**ICC A117.1 STANDARD**  
**THIRD PUBLIC REVIEW DRAFT**  
**SUPPLEMENT**

July 2, 2015  
Updated through June 20, 2016

## ICC A117.1 Standard – Accessible and Usable Buildings and Facilities Third Public Review Draft - Supplement

### Editorial Review – 2015/2016

Figure 406.5.2 Grade break

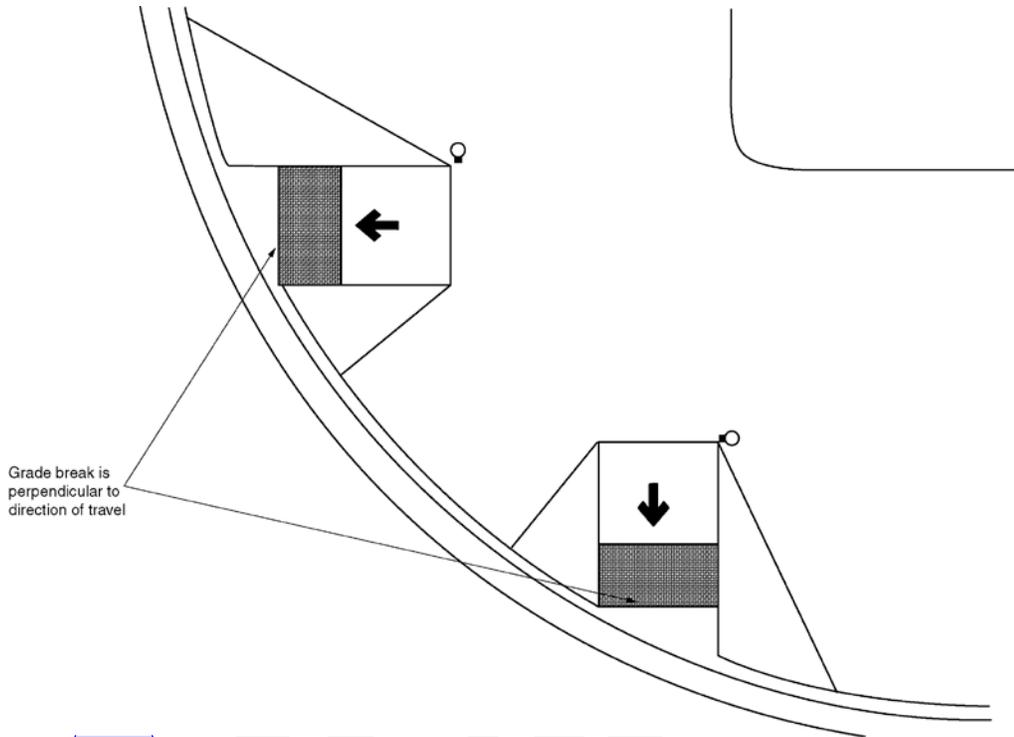
Comment [KP12]: Take off small circles

Figure 406.5.5 Clear space a bottom of curb ramps and blended transitions.

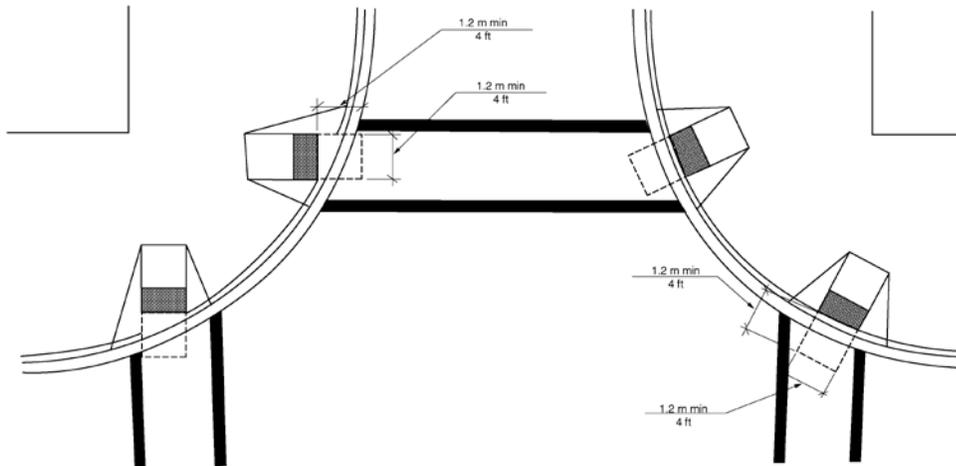
Comment [KP13]: Reverse meters and feet
